ADDENDUM NO. 2

DATE OF ISSUANCE:	April 22, 2024
PROJECT:	2024 Addition and Renovations North Harrison Elementary School 1115 W. Whiskey Run Road Ramsey, IN 47166
OWNER:	North Harrison Community Schools
ARCHITECT'S PROJECT NO.:	23-228.001
ORIGINAL BID ISSUE DATE:	April 03, 2024

SHEET TITLE
WALL SECTIONS

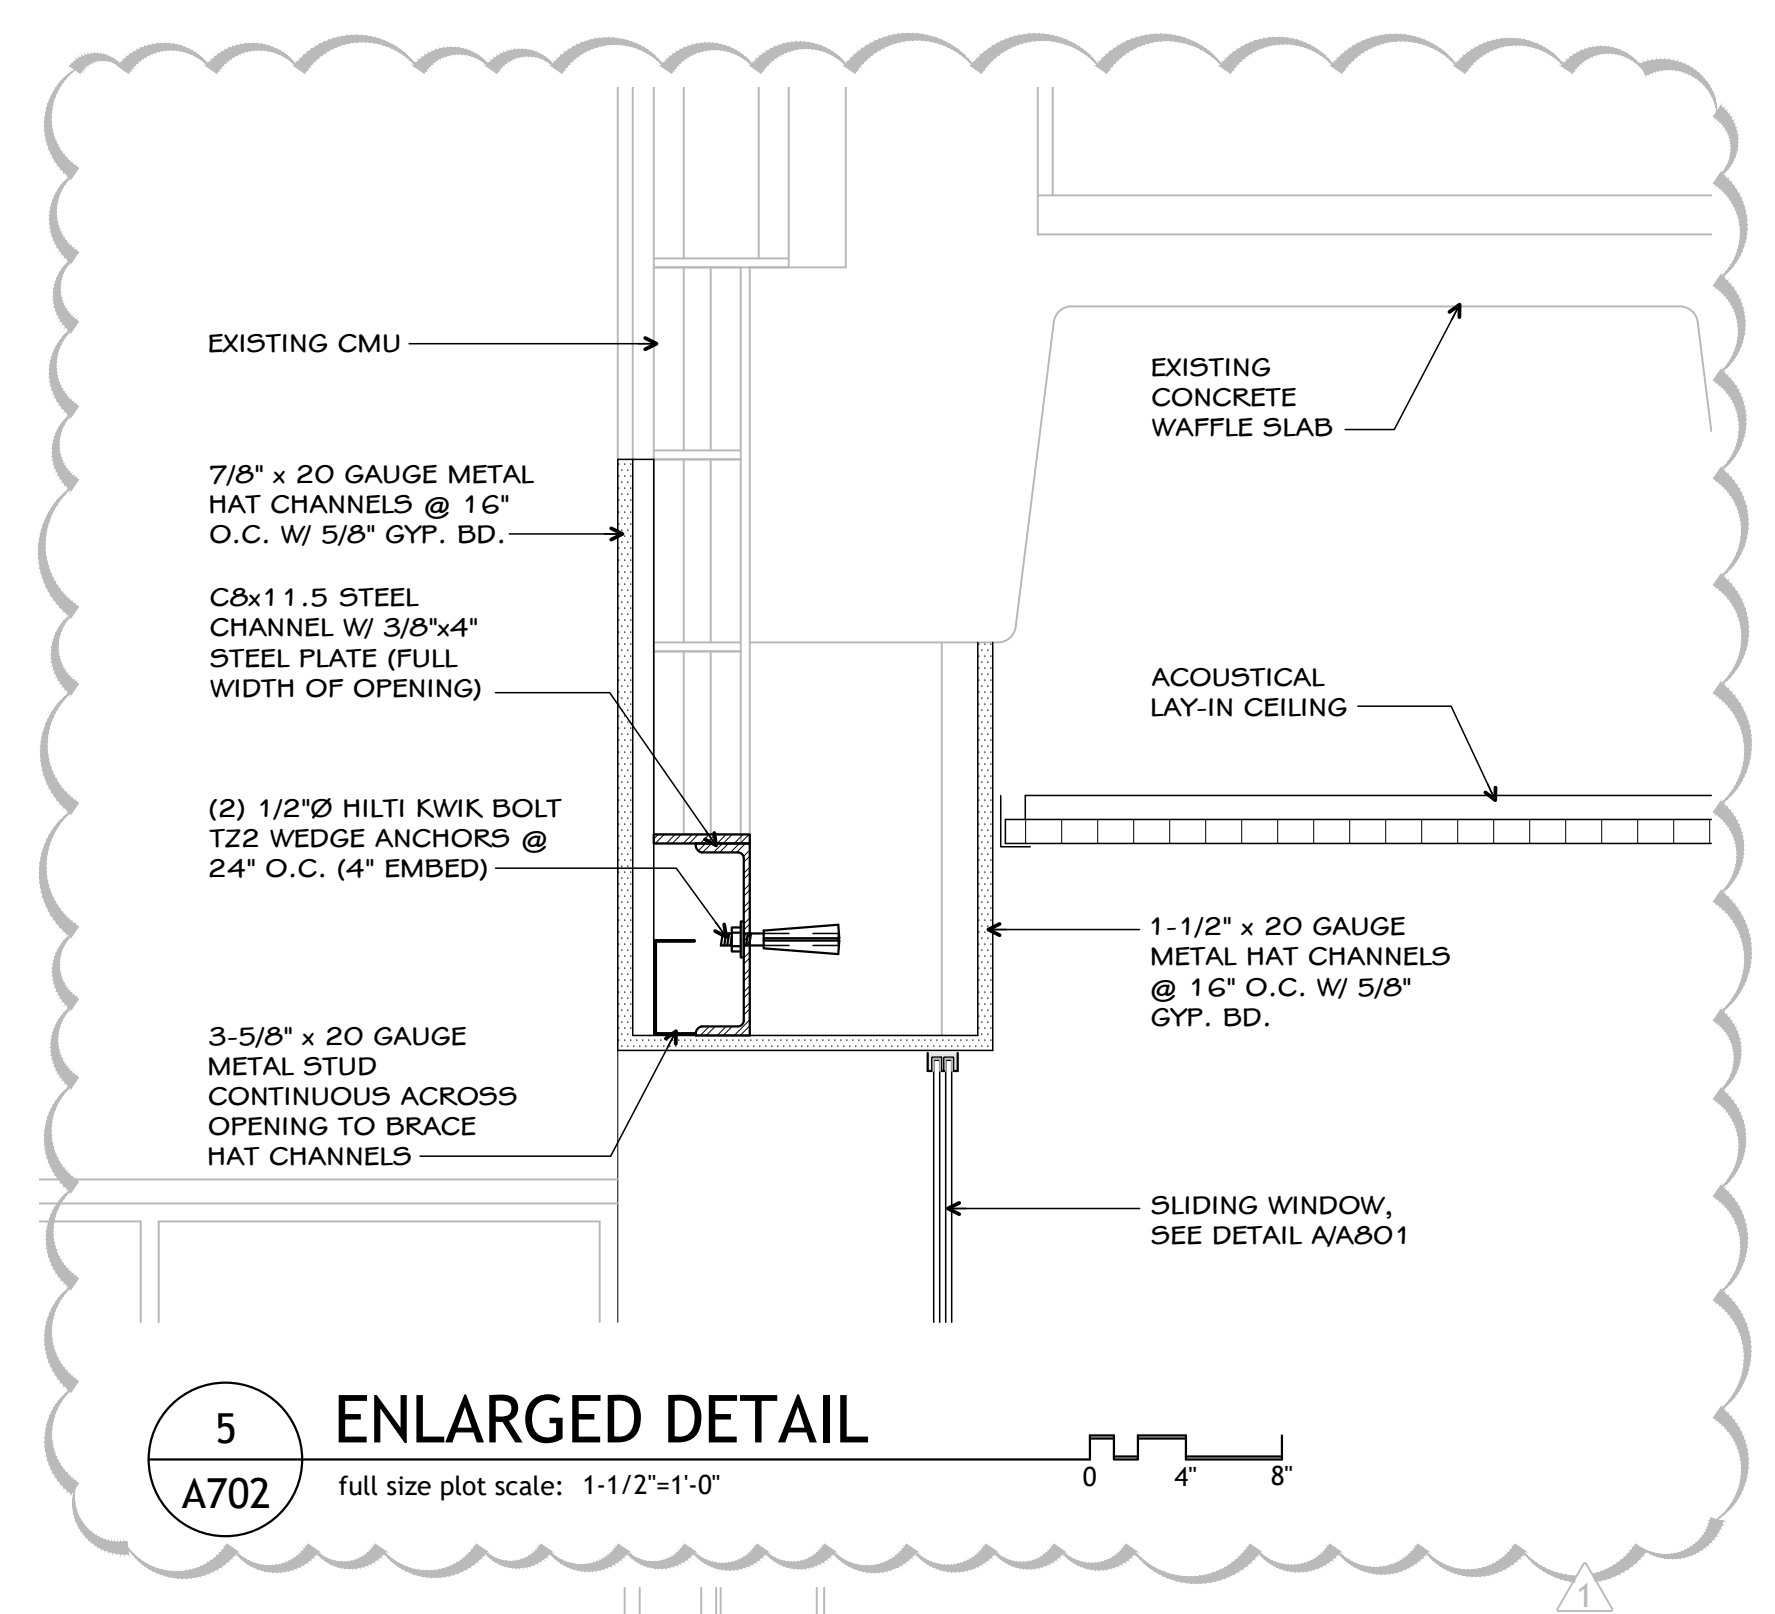
Replace with attached revised Drawing in its entirety; revisions have been clouded for reference. Details added for lintels at openings through existing walls.

SHEET NUMBER
P400

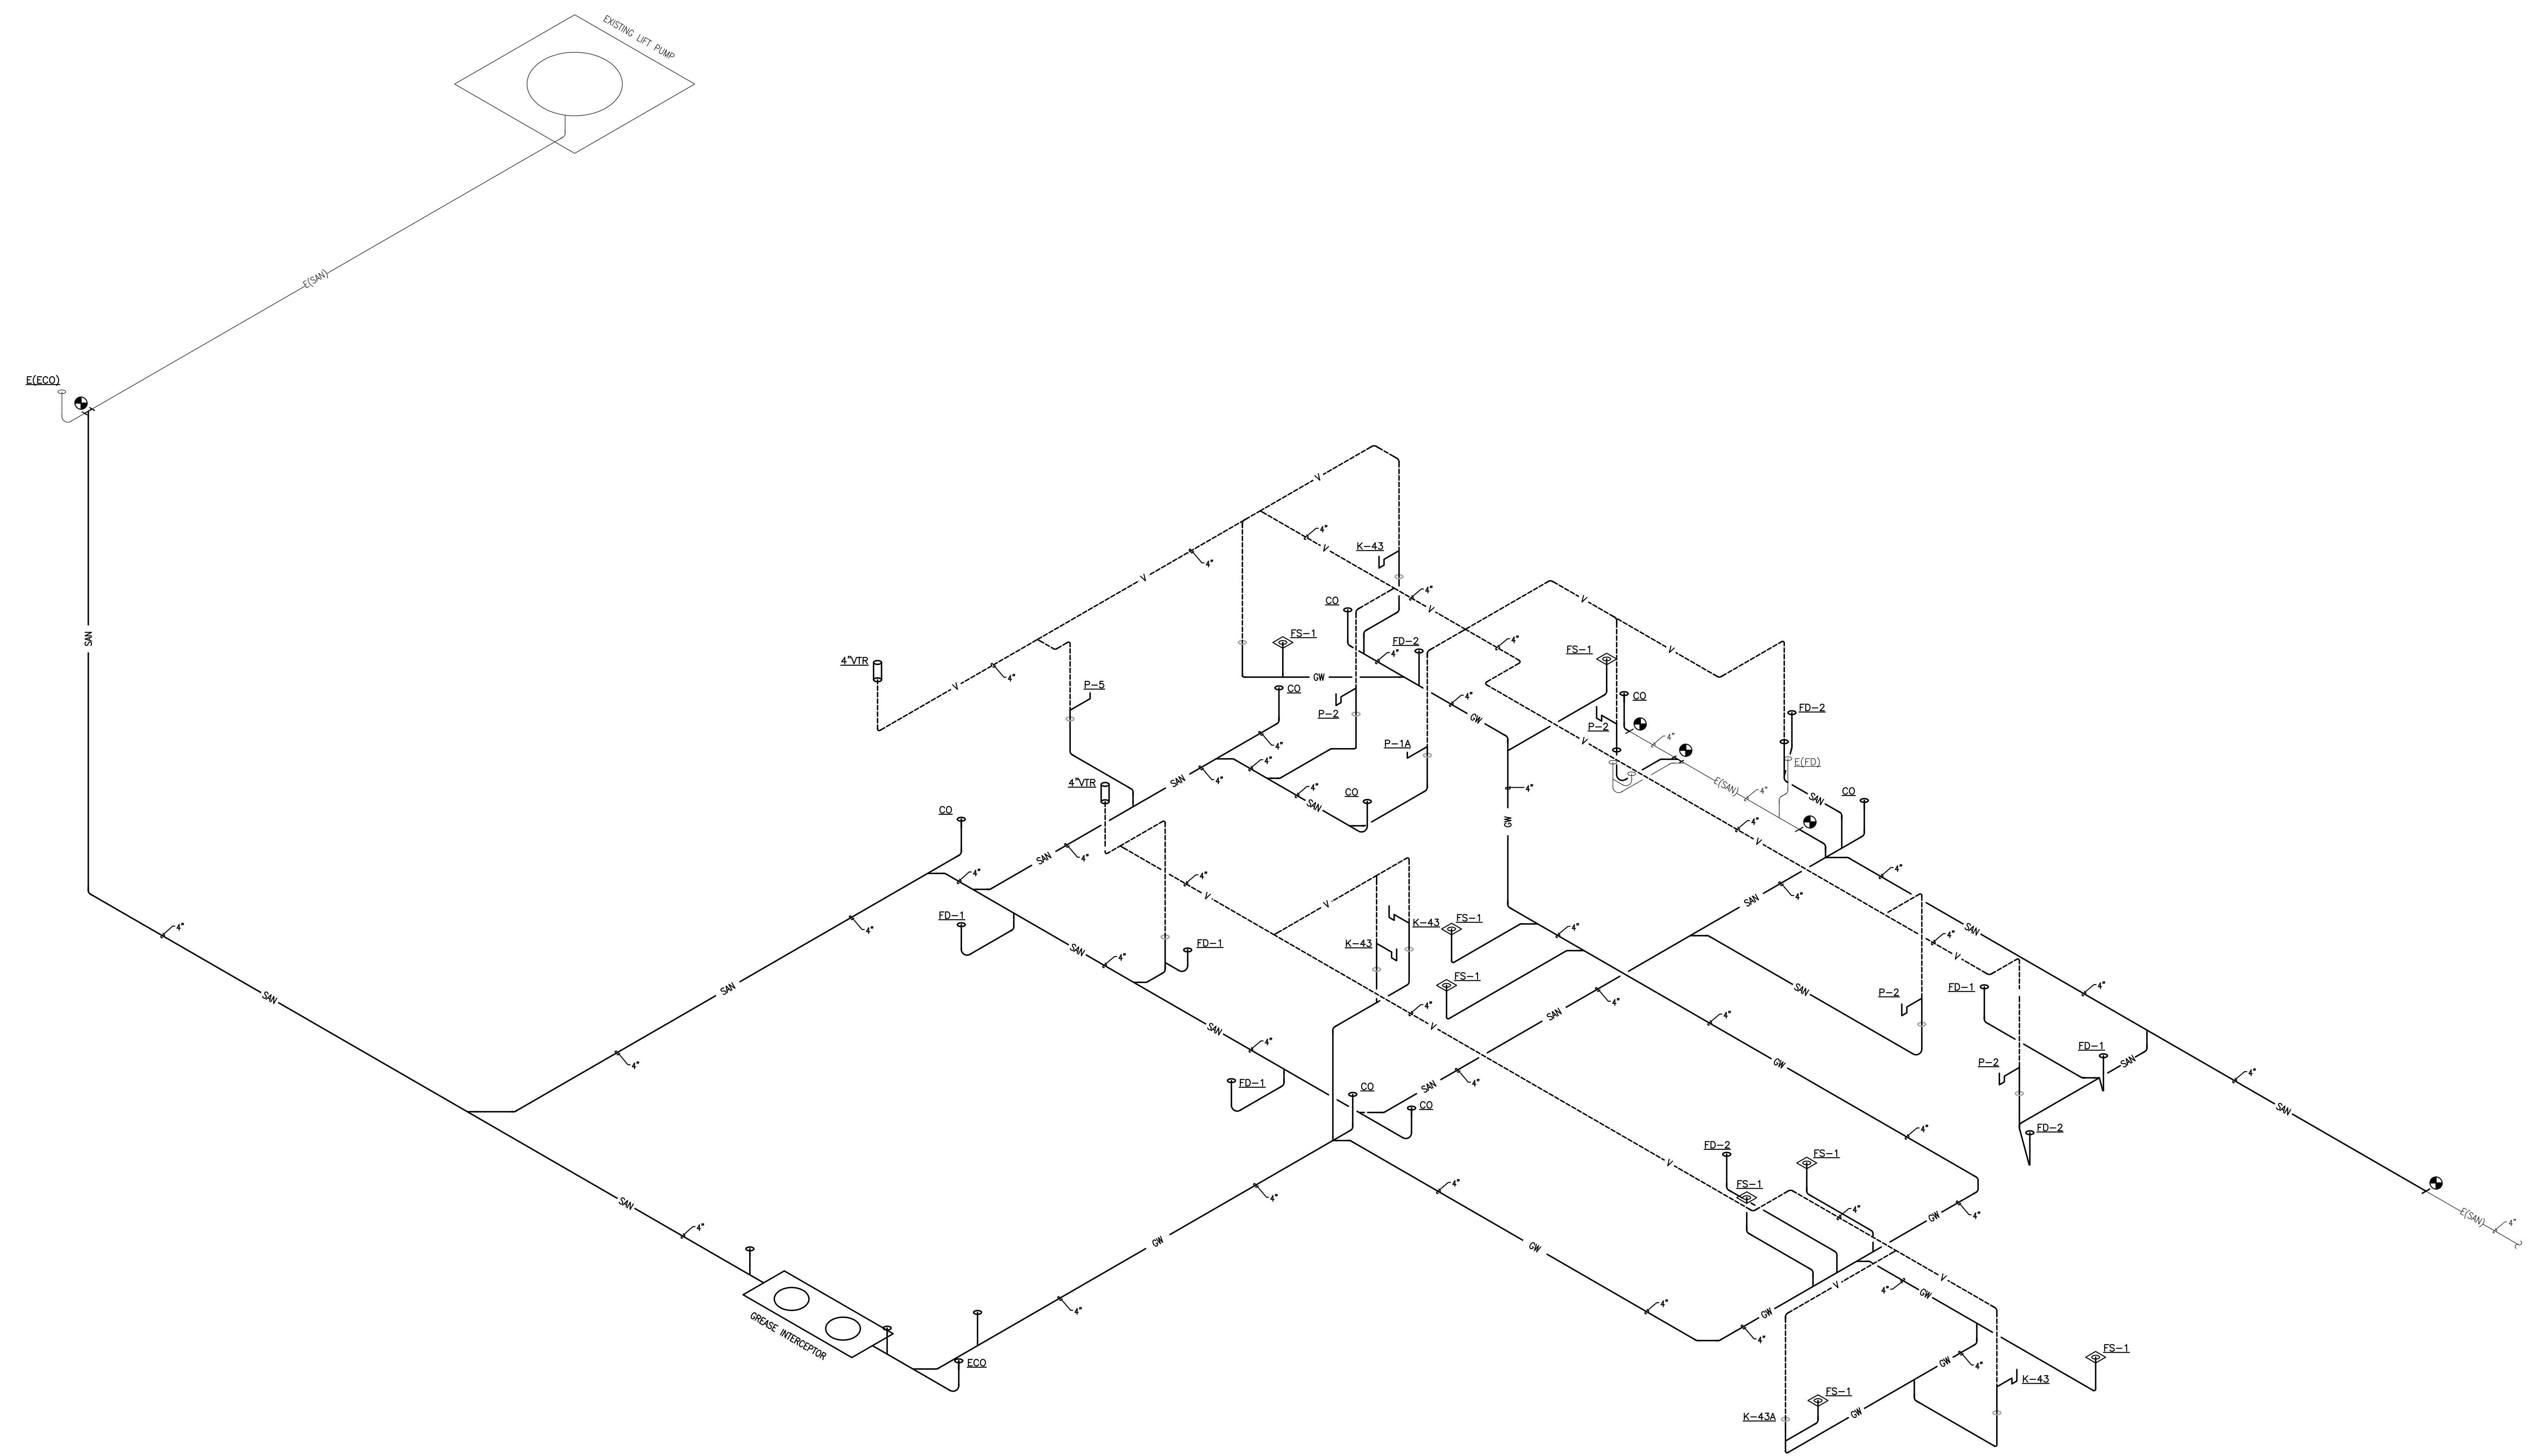
ADD-2 Item No. D-14 - Plumbing Riser Diagrams

The sheet is to be included in the set for the riser diagrams.
